IMMINGHAM EASTERN RO-RO TERMINAL

Cover Letter to PINS regarding the
Applicant's Deadline 3 Submissions

Document Reference: 10.2.25

Immingham Eastern Ro-Ro Terminal (TR030007) Deadline 3 Submission

Figure 1. Predicted airborne noise (L_{Amax}) during piling at the outer finger pier with noise suppression system

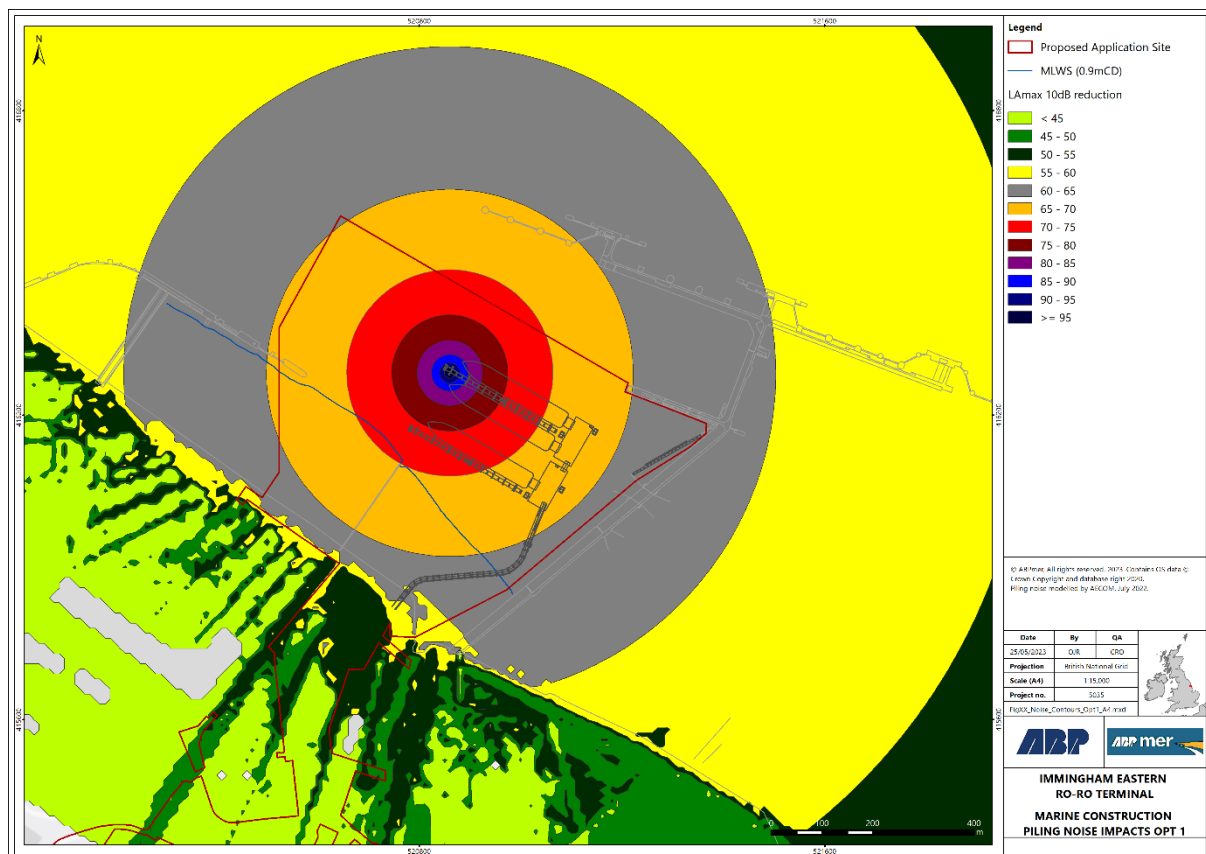
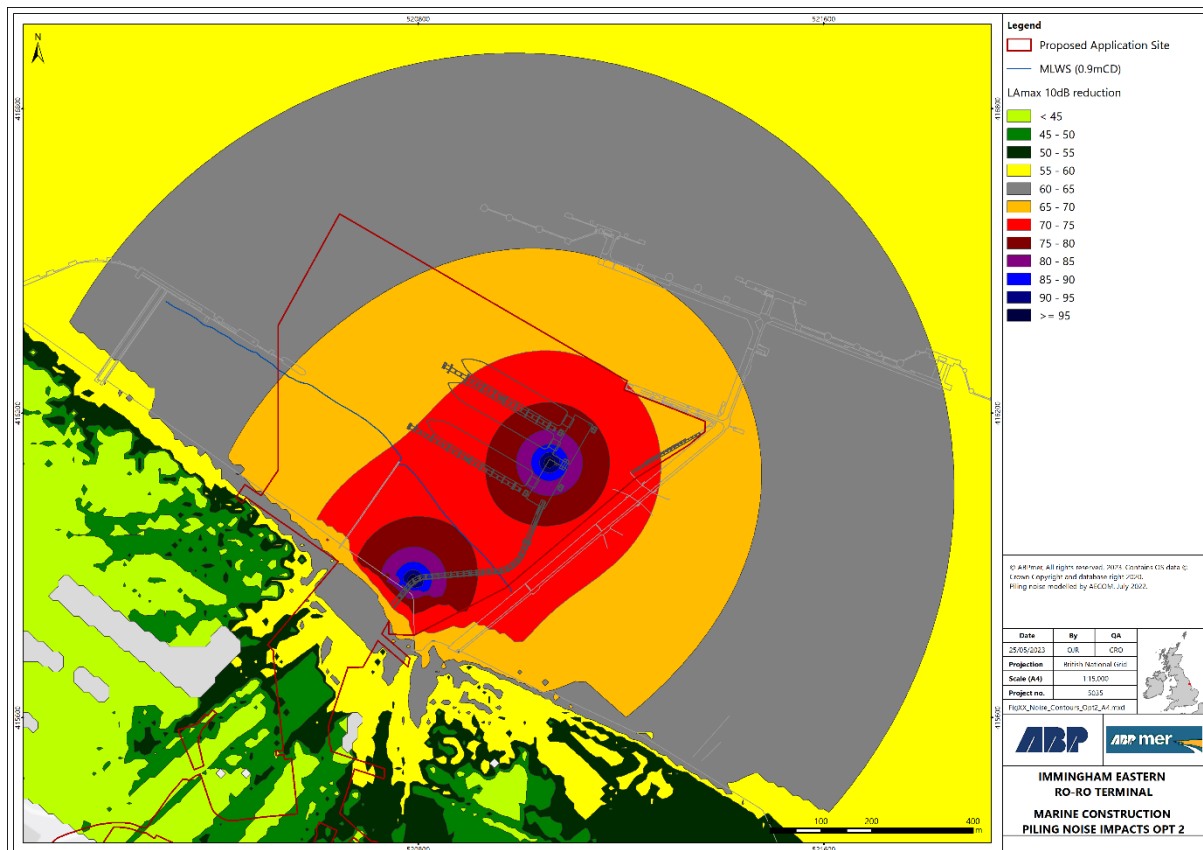
4) *Expected noise levels during piling and other construction activities at 200 m and 300 m from the source*

4.12. Airborne noise modelling (undertaken by AECOM Ltd.) was used to inform the assessments in the IERRT ES and HRA. Paragraph 9.8.189 of Chapter 9 of the ES and paragraph 4.10.19 of the HRA sets out expected noise levels during percussive piling, and paragraph 4.10.35 of Chapter 9 of the ES and paragraph 9.9.5 of the HRA sets out the expected noise levels with mitigation in place in the form of the noise suppression system. The AECOM figures which supported the assessment are provided below demonstrating that beyond 200 m from the piling works, noise levels are predicted to be below 70 dB L_{Amax} with the use of the noise suppression system.
